Service Bulletin

PRELIMINARY INFORMATION

Subject: Low A/C Refrigerant Level (Compressor To Condenser Line)

Models: 2015 Cadillac Escalade Models
2014 - 2015 Chevrolet Silverado 1500
2015 Chevrolet Suburban, Tahoe
2014 – 2015 GMC Sierra 1500
2015 GMC Yukon Models

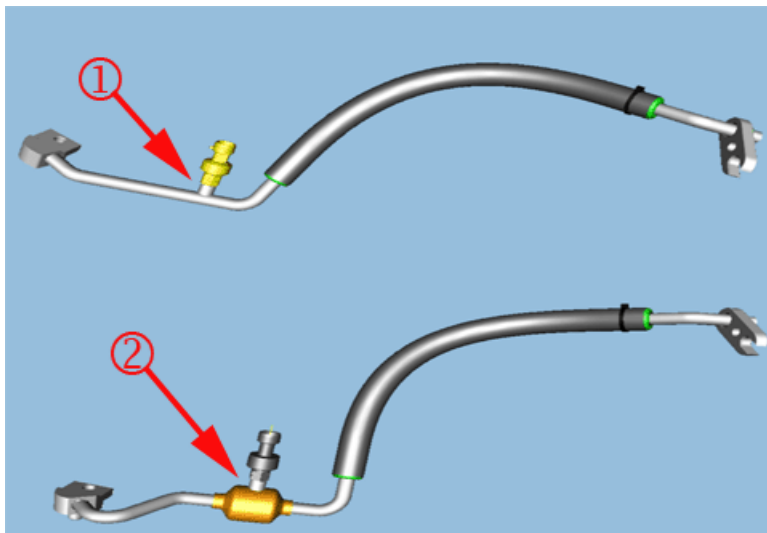
Note: This information applies to all 2014 models and early built 2015 models which have a muffler in the compressor to condenser line (2). Shown below are pictures of the compressor to condenser line with the muffler (2) and without a muffler (1).

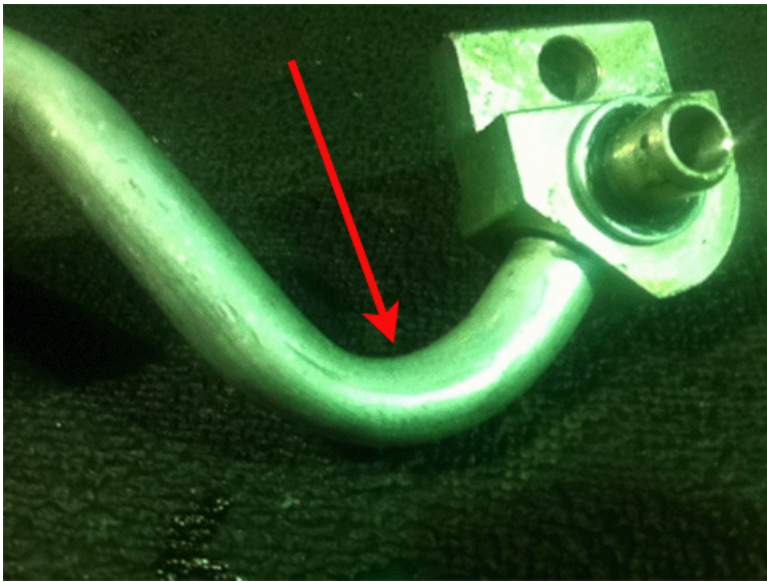
The compressor to condenser line may have a small crack or pin hole located at the inside radius of the first bend near the compressor, as shown below.

If the a/c line cracks, it may spray oil and refrigerant onto the a/c compressor, making the source of the leak very hard to identify.

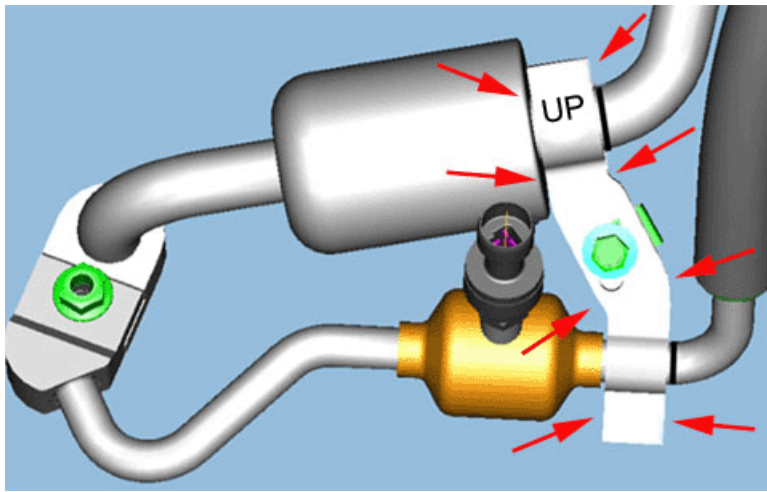
To repair this condition and prevent it from reoccurring, replace the compressor to condenser line and install the line bracket shown below.

1. Replace the a/c compressor to condenser line, GM part number 23438932 following the appropriate SI replacement procedure.
2. Install line bracket part number 23264893 as shown below and torque bracket bolt to 5.5 - 8 ft lbs (7.5-10.5 NM)
